R E M A R K S

Serial Number 09/580,411

Version with markings to show changes made.

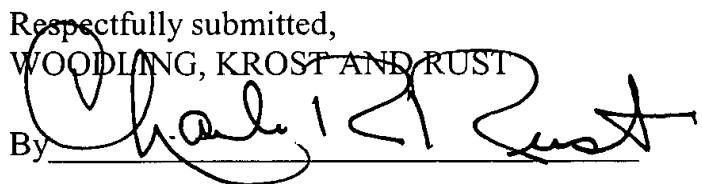
This amendment is in response to the office action dated September 13, 2001. In this action the examiner disapproved the proposed correction to Figure 8 of the drawings. In this amendment it is believed that the drawing corrections have been correctly made in that a sheet showing in red the deletion to Figure 8 and also included is a sheet showing Figure 8 with the correction completed thereon.
